Re: USEPA Comments on the Design Plan and Specifications Preliminary Basis
of Design, dated October, 2011 – Tyco Safety Products – Ansul Stanton Street
Facility
EPA #WID 006 125 215

TECHNICAL REVIEW OF THE PRELIMINARY BASIS OF DESIGN DESIGN PLAN AND SPECIFICATIONS DATED OCTOBER 2011

TYCO FIRE PRODUCTS LP
FORMER ANSUL INCORPORATED FACILITY
MARINETTE, WISCONSIN
EPA ID NO. WID 006125215

Appendix E
Remediation Schedule

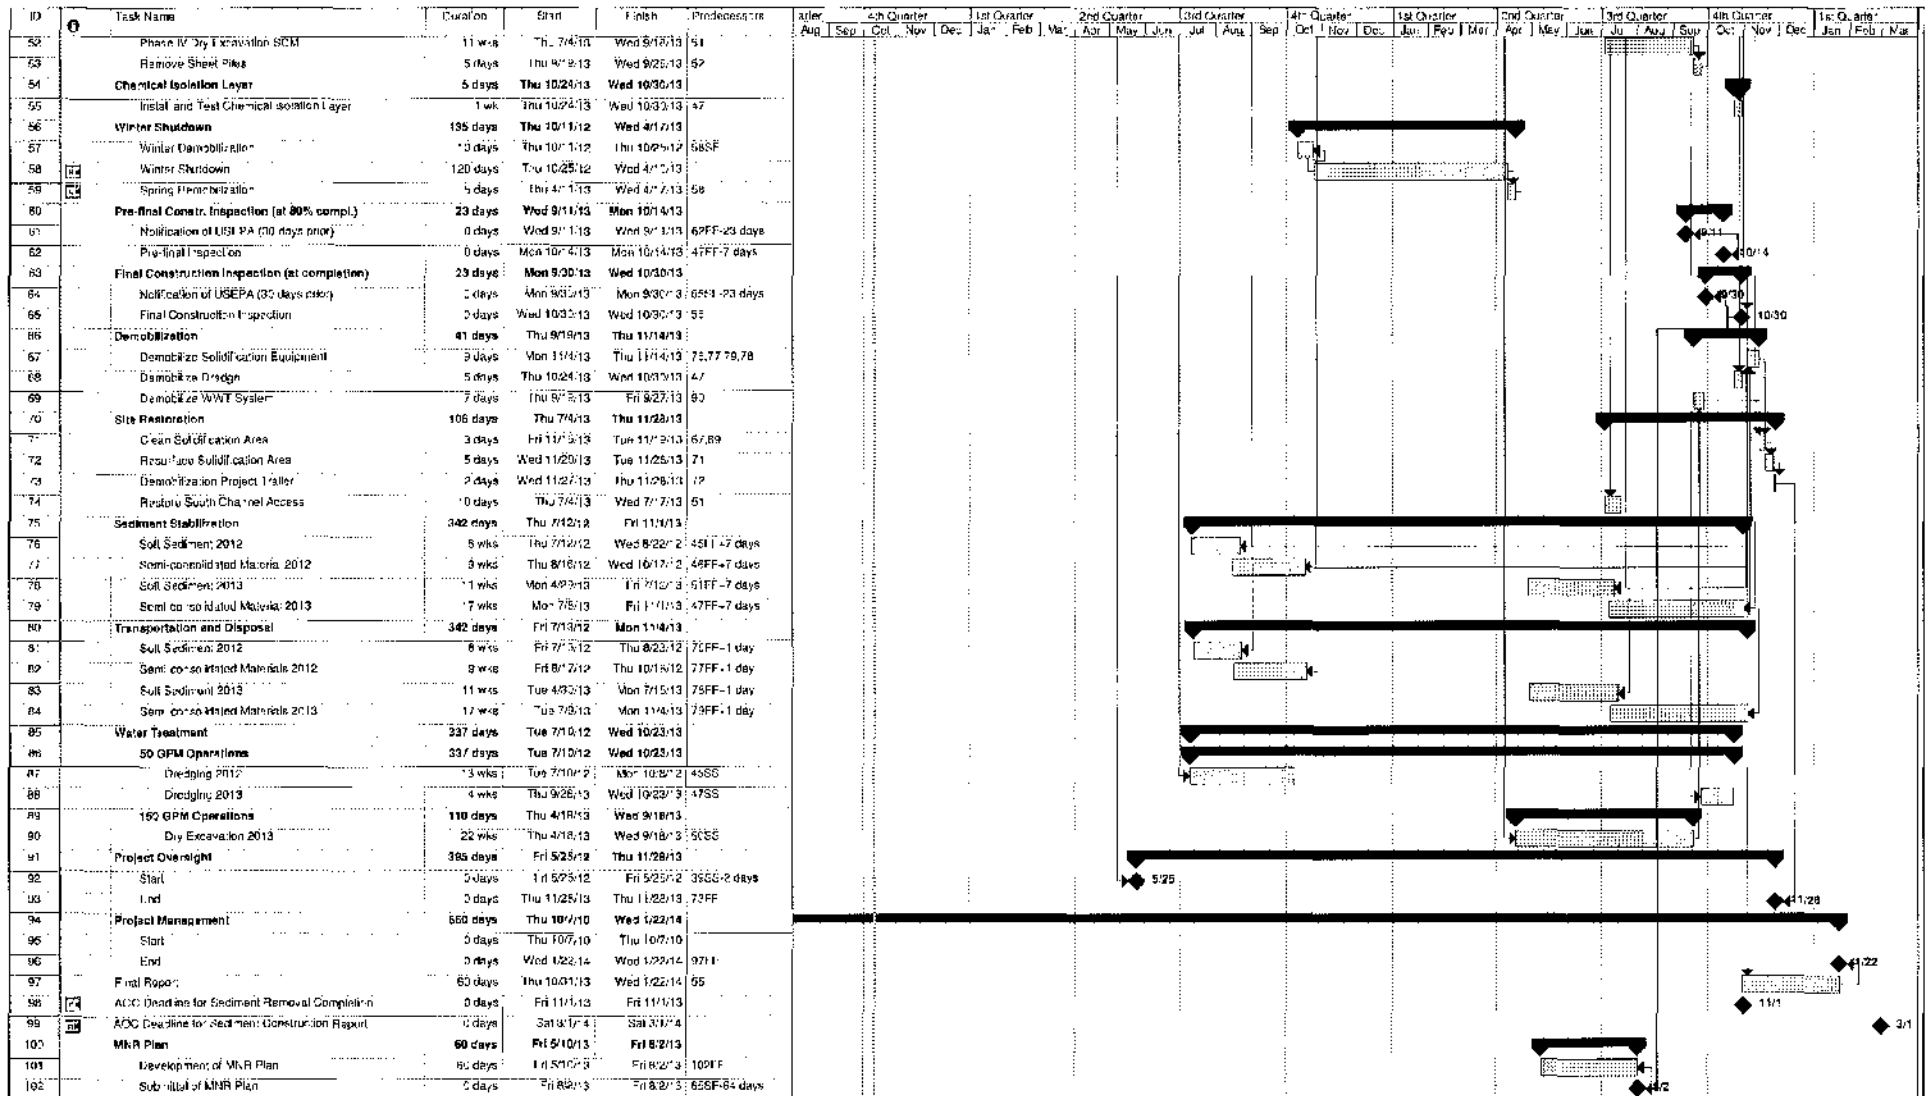
- 1) USEPA approves the remediation schedule contained in Appendix E, Remediation Schedule, of the DPS with the exception of items 54 and 55 (chemical isolation layer installation). Appendix E replaces the schedule USEPA previously approved and contained in Appendix D, Project Schedule, of the December 2010 approved Sediment Remediation Work Plan (SRWP). Appendix E is included as Attachment 1 to this letter and is hereby incorporated by reference into the AOC.

- 6) Provide as part of the Final Design Document a revised Appendix E showing specific dates for submission of permit applications, elimination of items related to chemical isolation and a schedule for site restoration. Provide a copy of the permit applications as they are submitted to the appropriate regulatory authority.
